TECHNICAL BULLETIN

[Issue No.] T11-0003

[Title] Recommendation of change over to
A60MXTN/A60MXRN model from A60MXT/A60MXR

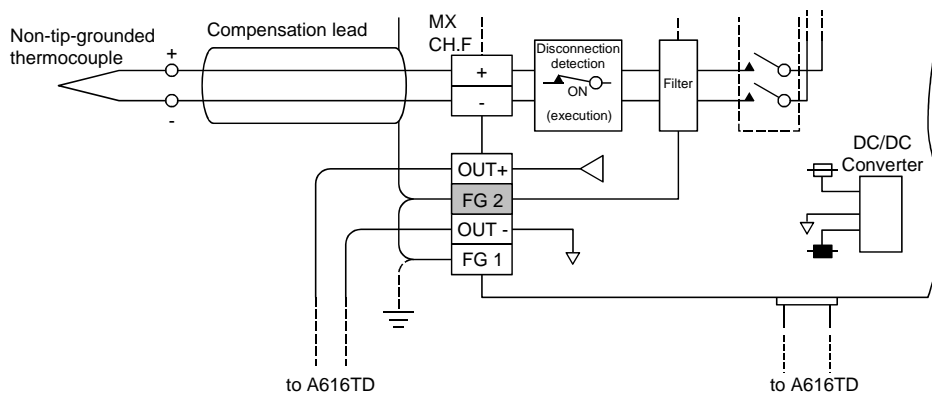
(1) Transition from A60MXT to A60MXTN

- (a) The programs created for the A60MXT are usable without any modifications.
- (b) A60MXTN provides channel isolation of 400V DC (Guaranteed: 100V DC), while A60MXT provides 500V DC (Guaranteed: 500V DC).
- (c) The wiring for the A60MXTN needs to be modified, as it includes an additional terminal (FG2).
